To: Michael Bisch
From: John M. Lichter, M.S.
ASCA Registered Consulting Arborist #375, ISA Certified Master Arborist #863,
ISA Qualified Tree Risk Assessor
Date: February 29, 2016
Re: Tree Preservation, City of Davis Greenbelt Trees, Hyatt House Project

PRELIMINARY GRADING AND DRAINAGE PLAN
2750 COWELL BOULEVARD
HYATT HOUSE
CITY OF DAVIS
APN: 069-0390-031
CALIFORNIA

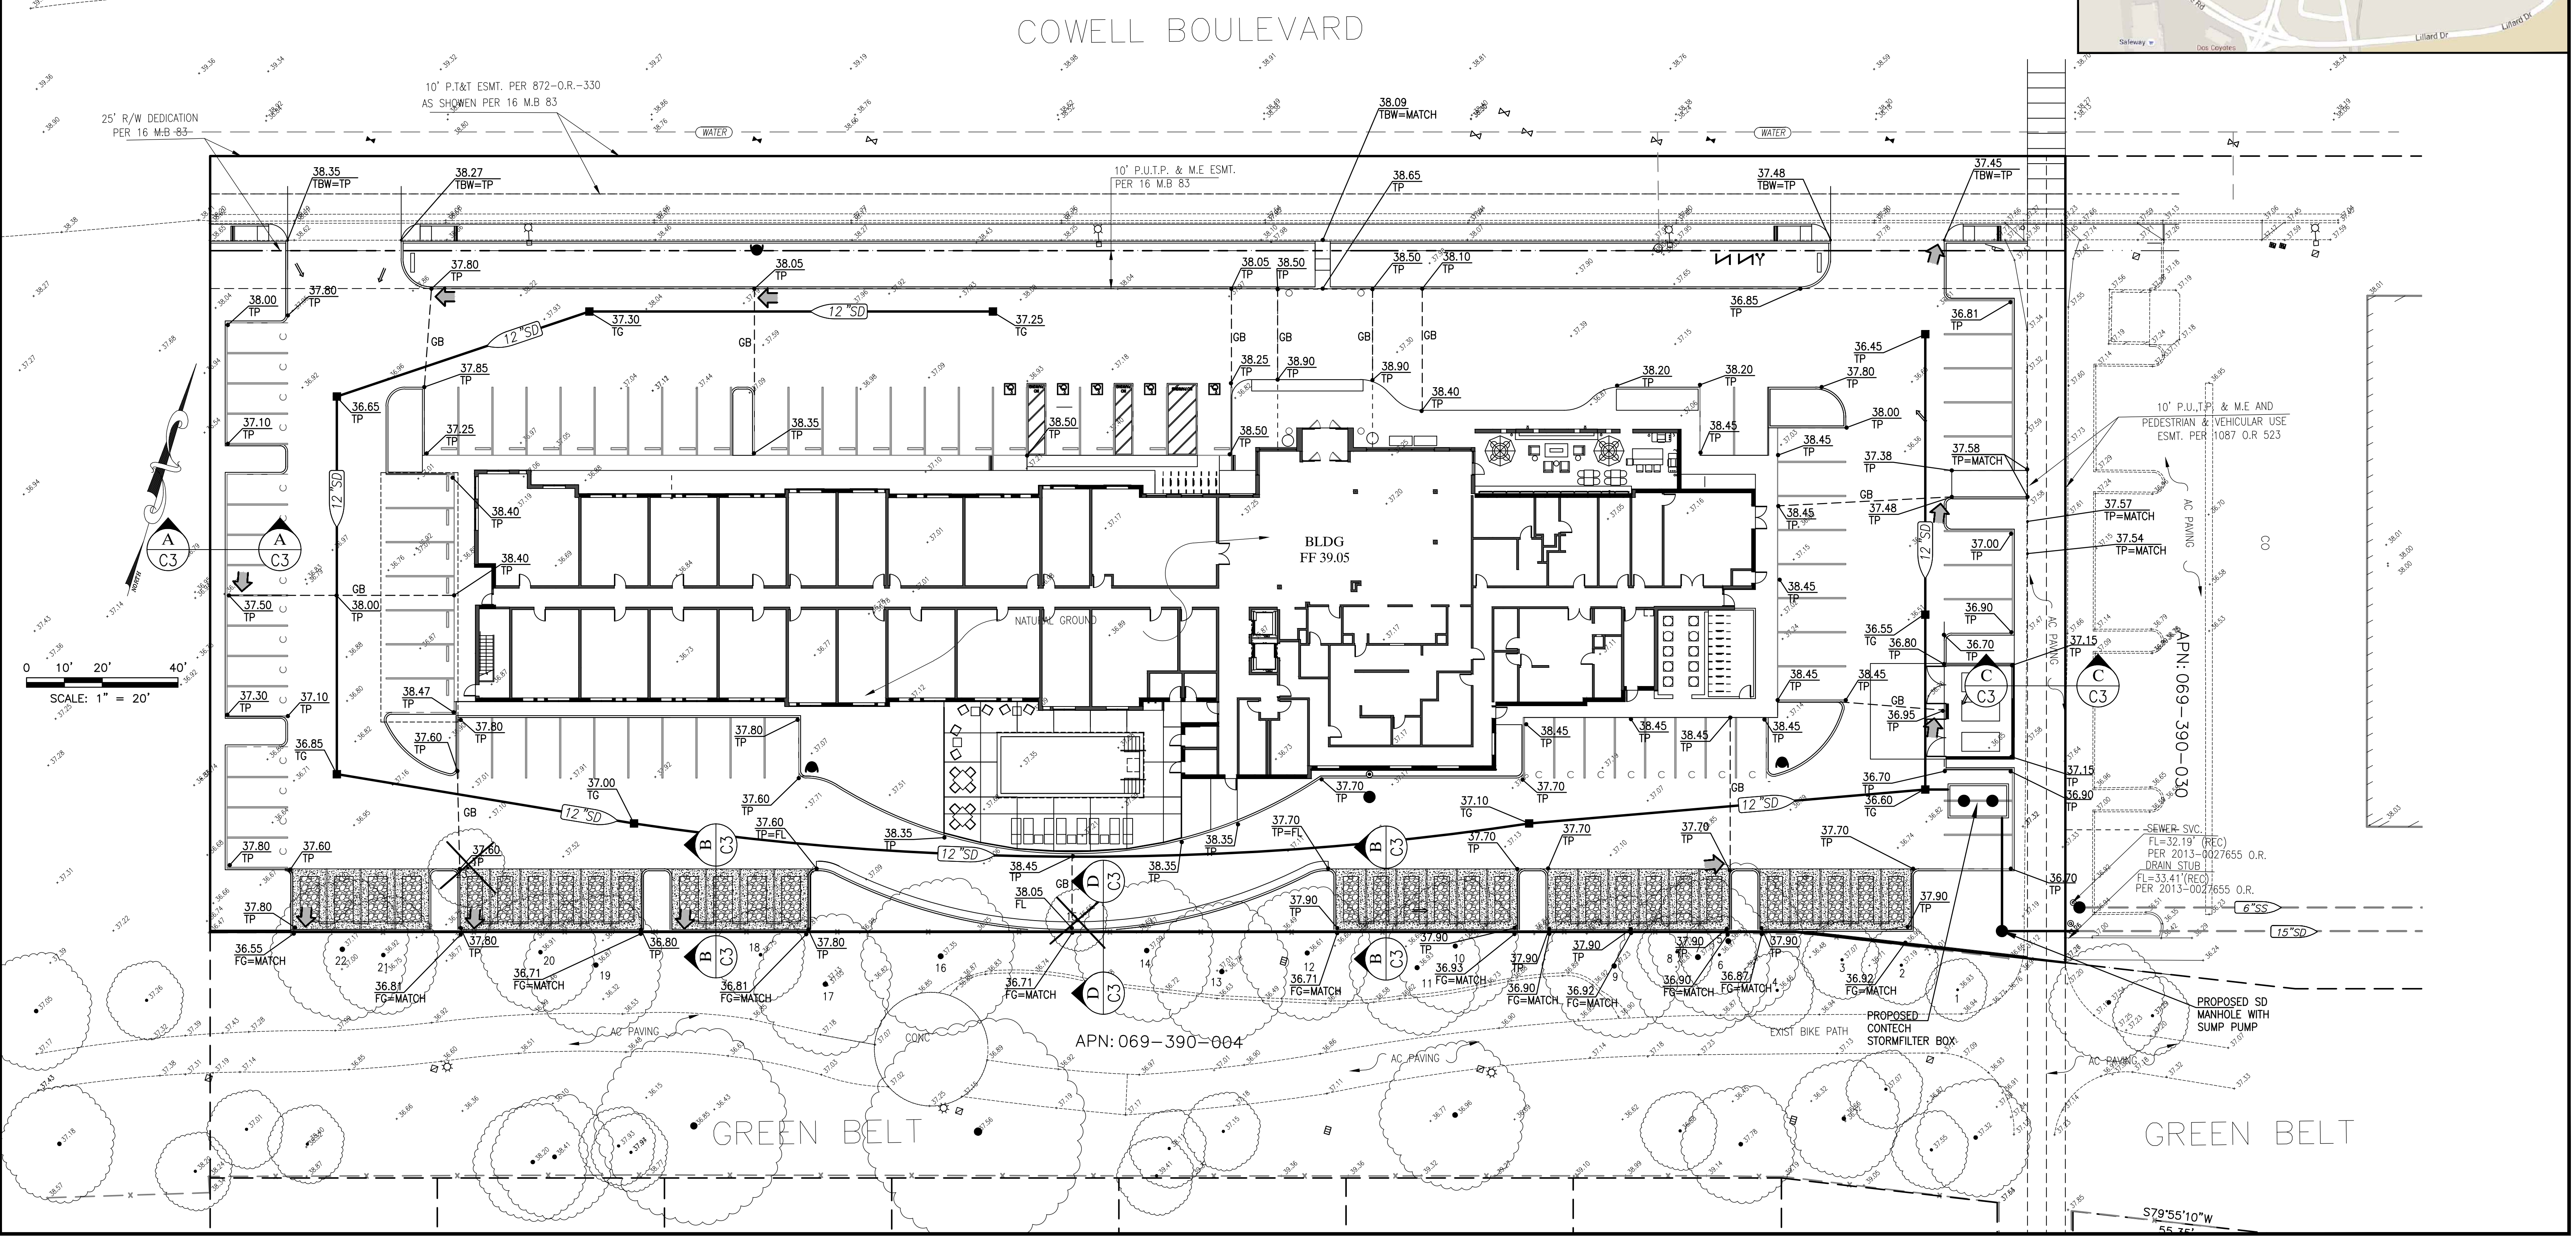
The fire lane is sufficiently far from the subject trees to pose no significant impact with the exception of trees #12, 14 and 16 (see attached grading plan). The distance between the fire lane and the trees is approximately 5, 4 and 6 feet, respectively. The design team has indicated that the total extent of excavation and soil disturbance (scarification) will be limited to 12 inches to install the fire lane.

A 15-inch deep hand excavation adjacent to trees #12 and 14 one foot from the northern edge of the proposed fire lane within 12 feet of the trunks revealed no roots larger than 0.5 inches. Within twelve feet of the trunk of tree #16, one foot from the northern edge of the fire lane, I tile-probed (with a sharpened steel rod) to a depth of greater than 15 inches. In one location, we found two 0.75" diameter roots.

Given the above, I rated the level of development impact to these trees as low/moderate.

DETAILS SHEET
2750 COWELL BOULEVARD
 HYATT HOUSE
 CITY OF DAVIS
 APN: 069-0390-031
 CALIFORNIA

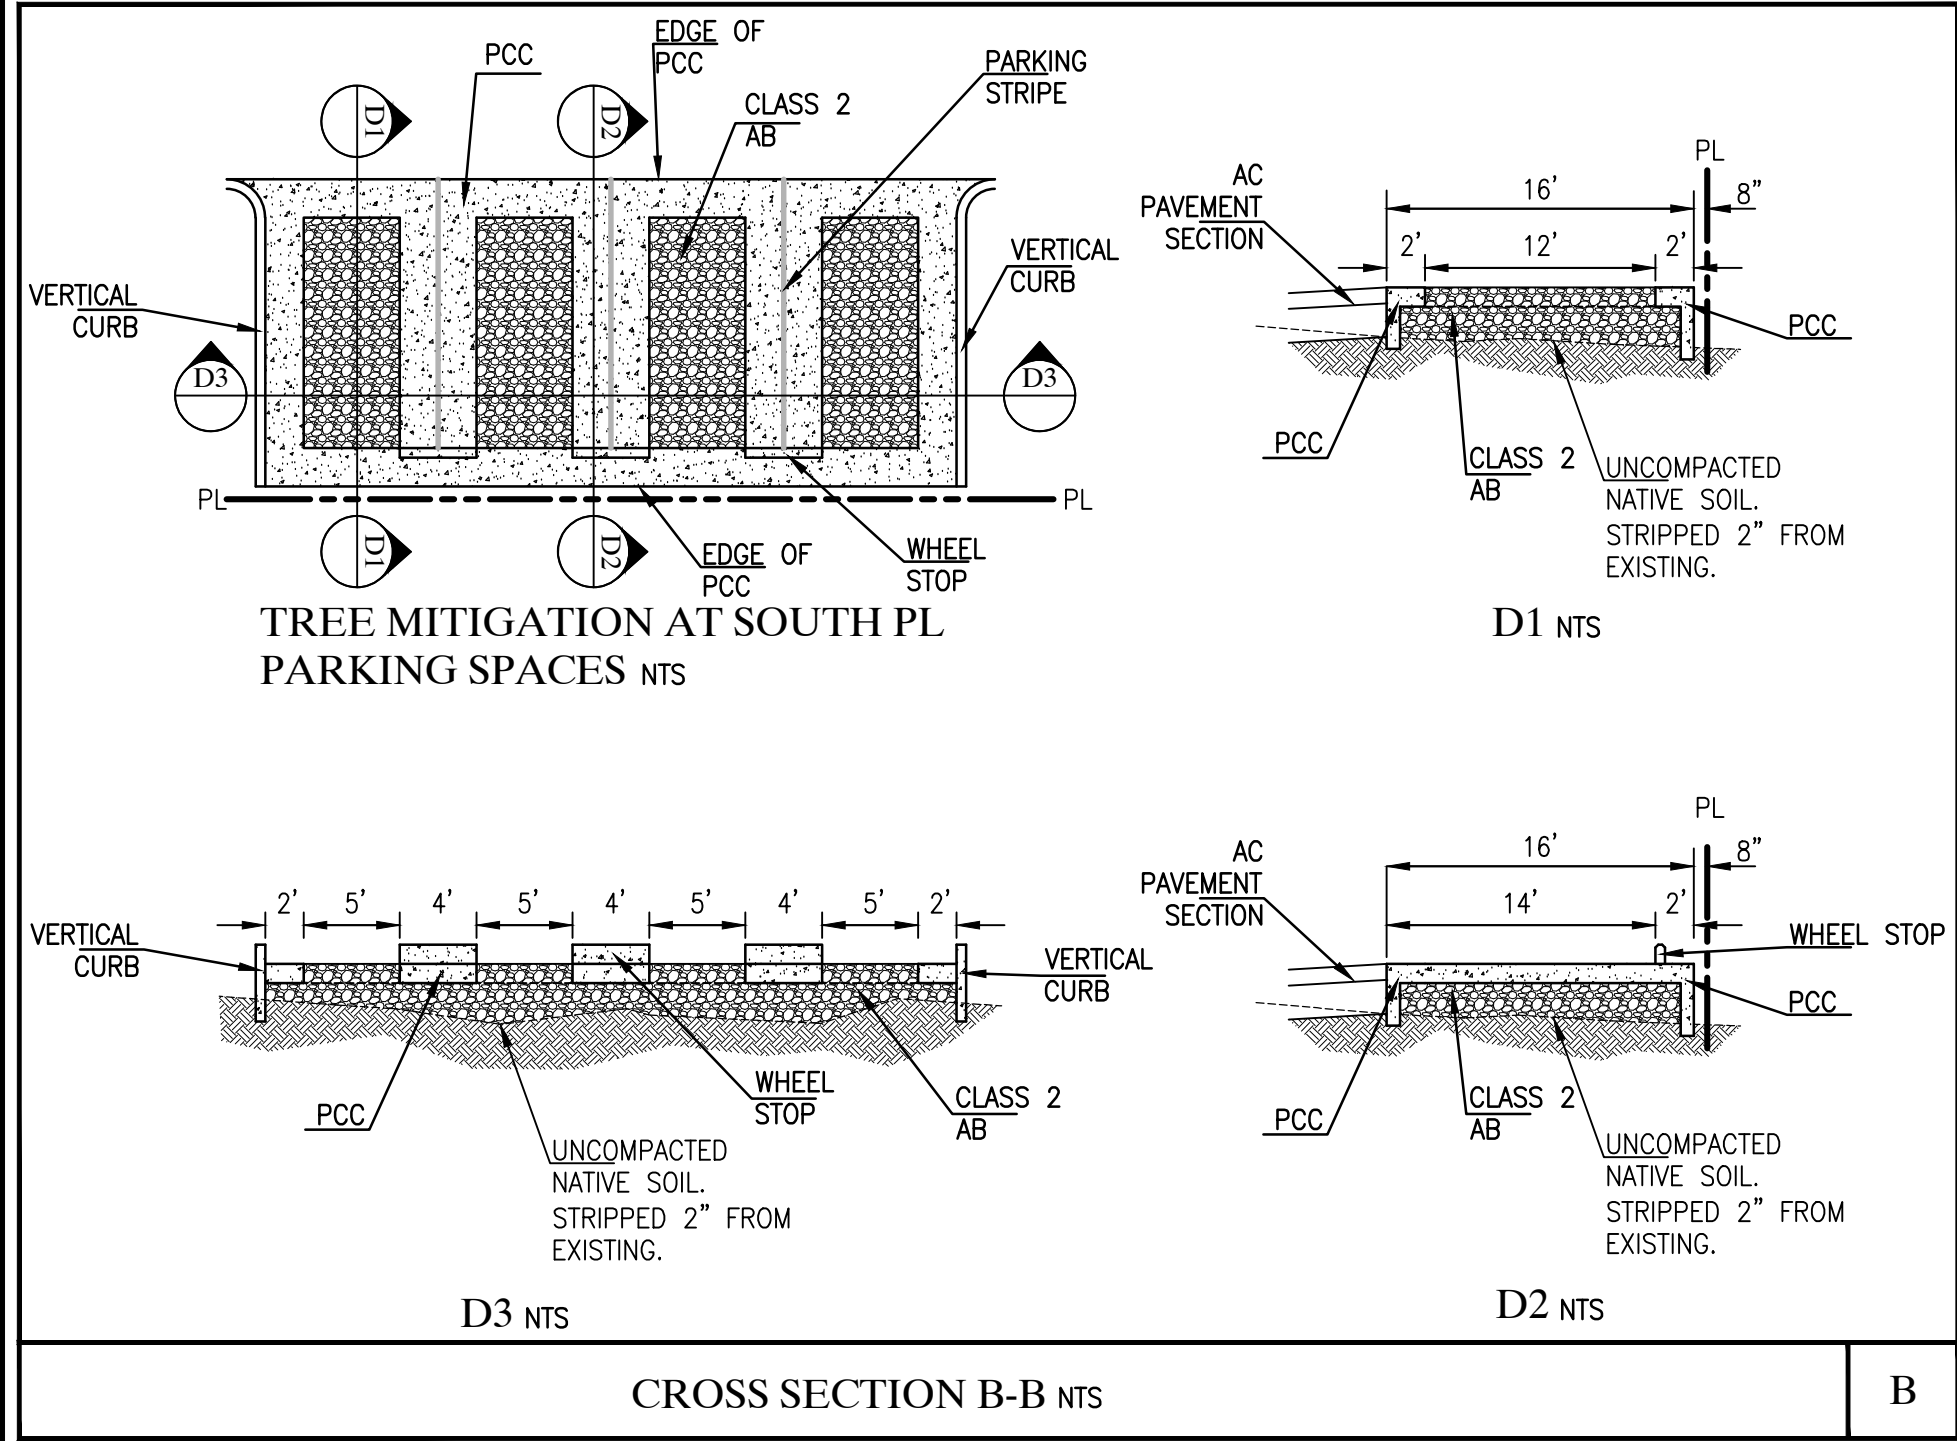
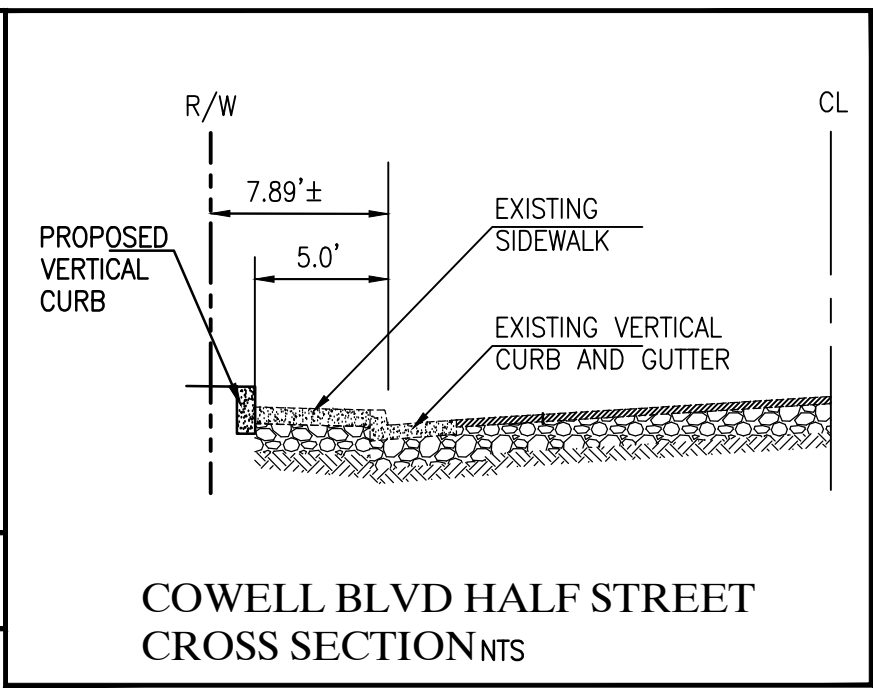
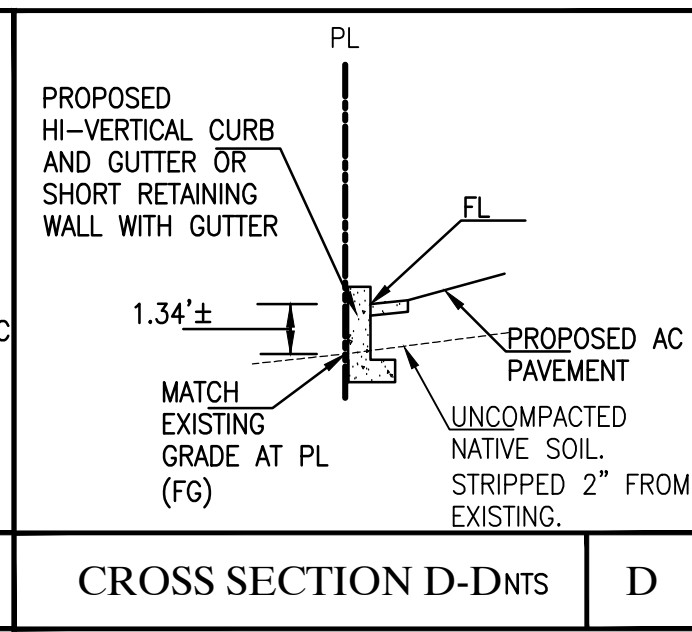
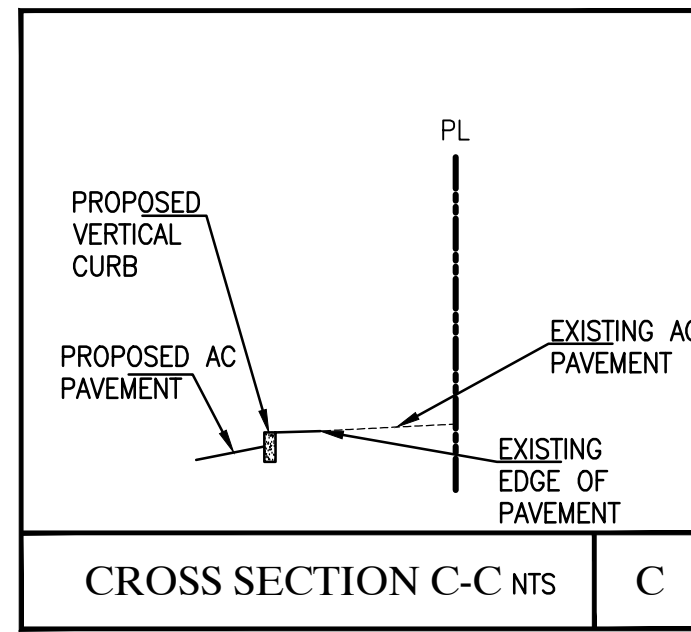
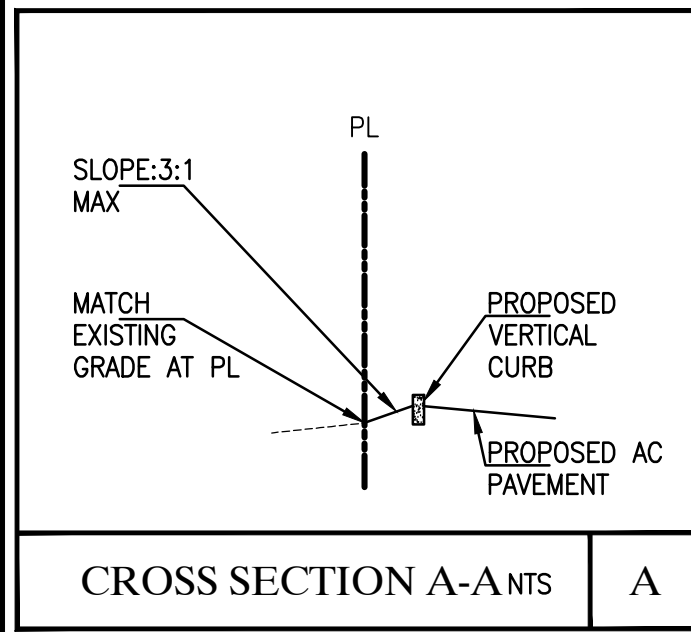
The proposed parking, which is located adjacent to the remaining greenbelt trees, involves installing gravel surrounded by poured concrete strips. The gravel is to be installed on uncompacted native soil (2" of soil stripped) with no scarification. The intent of this design is to avoid root injury and provide adequate soil moisture and structure to allow continued root growth.

- Revise parking lot detail to utilize drain rock rather than AB in between concrete strips.
- Specify on plans to excavate for curb installation with water or air under ISA Certified Arborist supervision. If roots greater than or equal to 2 inches in diameter are encountered, bridge curb over roots allowing space for roots to expand in girth.
